Publication No. 79-e29

M E M O R A N D U M

To: Chet Rock and Roger Stanley
From: Bill Yake
Subject: Crown Zellerbach - Port Townsend Class II Inspection

Figure 1

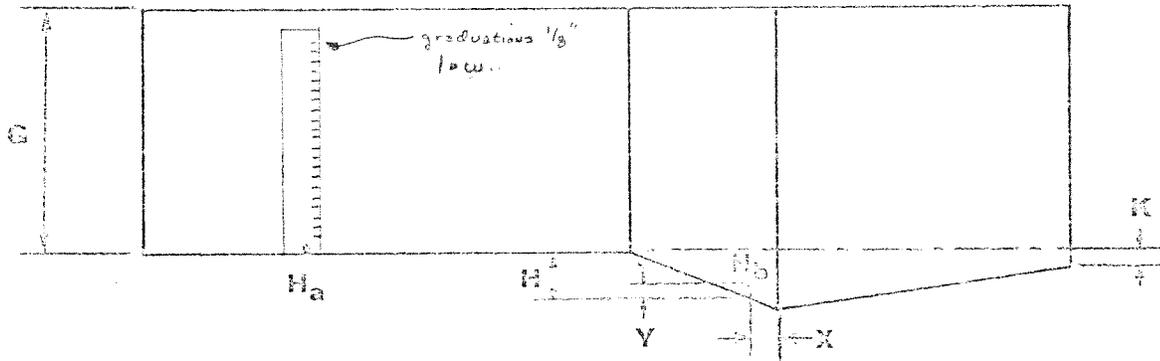
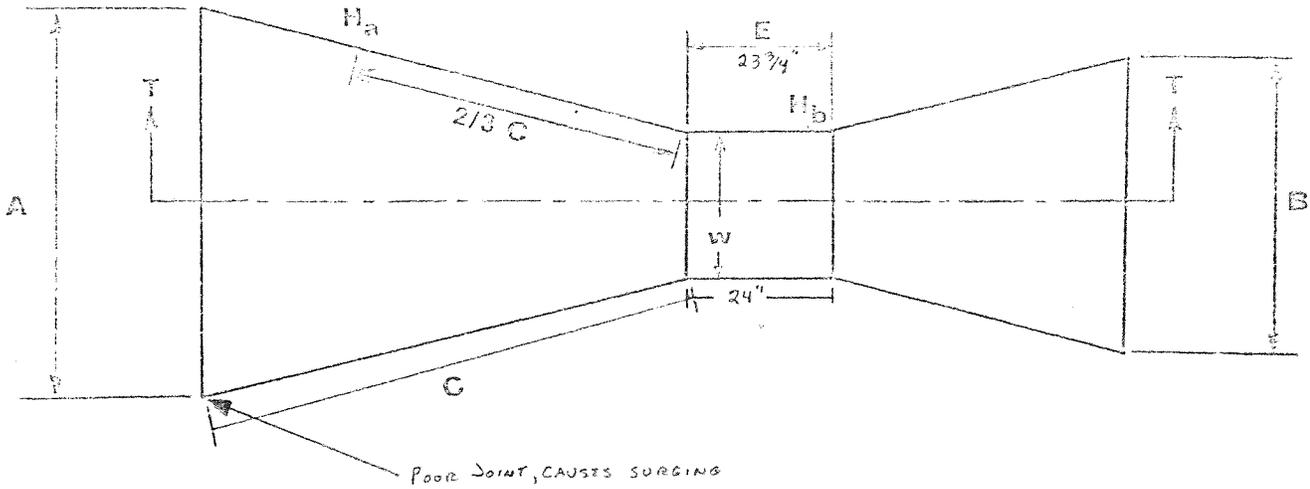
The ASB effluent Parshall flume was assessed to determine its accuracy. Although the dimensions of the flume were in close correspondence with specifications (see Figure 1, Parshall Flume), there were problems with approach and discharge design. The approach section allows only a short (about 5 feet) straight approach after a right angle turn. In addition, the joint between the approach channel and the converging section of the flumes is not smooth, leading to a substantial chop and a noisy flow record. The most serious design error, however, is the lack of an adequate discharge run. The channel is truncated by a cement wall with an inset outlet pipe. This backs up flow and appears to initiate submerged conditions at approximately 13-14 MGD. This means that recorded flow is somewhat higher than actual flow when flows exceed 13 MGD. Although actual flow is difficult to determine under these non-ideal conditions, flows recorded on the DMR's are probably within the ± 15 percent error limitations.

1. Type - Parshall Flume
2. Dimension - 2-foot throat
 - a. Meets standard criteria - YES, with reservations. Insufficient straight approach and rough bevels from approach to flume lead to surging in head well. Insufficient discharge distance leads to submergence at flows above 14 MGD and overestimations of higher flows.
 - b. Accuracy check - Based on actual head vs. totalizer. Does not account for submergence and other design imperfections.**
